**STAGE 1 ROAD SAFETY AUDIT
REPORT**

Laurclavagh Renewable Energy Project

Stage 1 Road Safety Audit

Figure 2.1 – L-61461 Local Road Looking East Near Site Access

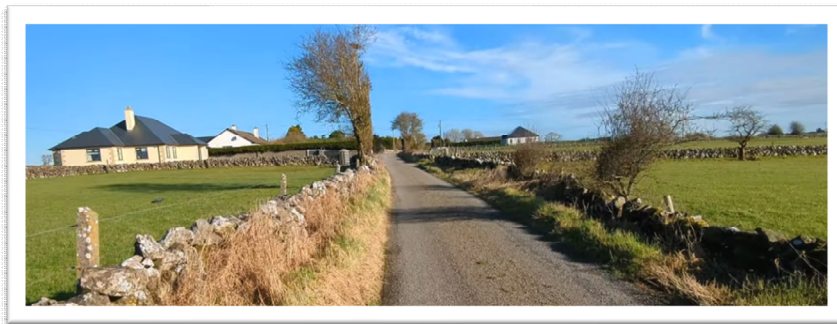
2.1 Problem: Space for Opposing HGV's to Pass

Location: Section of Local Road L-61461 to be Used by Construction Traffic

It's likely that in some locations, space will be limited for two opposing HGV's to pass each other on the L-61461. This could lead to opposition type conflicts or lengthy (and risky) reversing manoeuvres.

Appropriate measures should be set in place as part of the Construction Traffic Management Plan to manage the risks associated with opposing HGV conflicts on the L-61461.

2.1	Yes	Yes	It is proposed that that the approx. 270m section of the L-61461 between the proposed link road and the proposed access junction will have a minimum width of 5m, which will be sufficient for many of the construction vehicles to pass when moving slowly. A traffic management plan is also proposed as part of the EIAR to manage traffic volumes and minimise the potential for opposing HGVs to meet on this section of the L-61461. It is noted that site staff (Flagmen) will be on-site at all times during the construction phase to manage traffic construction traffic.

Figure 2.2 – Access Points 1 & 2 Were the General Public May Enter the Works Area

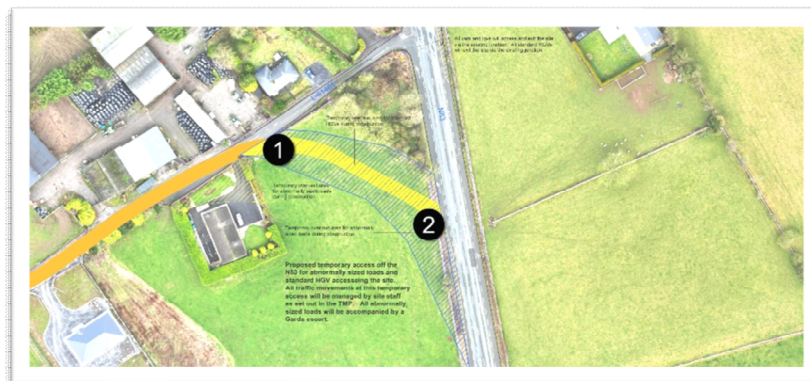
2.2 Problem: Errant Drivers Entering Works / Over-Run Area

Location: Temporary Over-Run Area for HGV;s Linking N83 to L-61461

The opening of the over-run area for abnormal loads and construction traffic could create driver confusion, leading to errant drivers (i.e. the general public) accessing the windfarm construction site in error.

Access to the over-run area should be managed appropriately whilst being used for construction traffic to avoid errant drivers entering the works. Access points 1 and 2 should be closed when not required by construction traffic.

2.2	Yes	Yes	The default for the temporary over-run area connecting the N83 to the L-61461 will be that it will be closed to all traffic by means of gates / fencing. During times when this area is being used for construction traffic the access at both ends will be managed at all times by means of signing and site staff (Flagmen), and during the delivery of the abnormally sized loads, by Garda escort vehicles. On completion of the construction phase the link road will be permanently closed with boundary fencing.
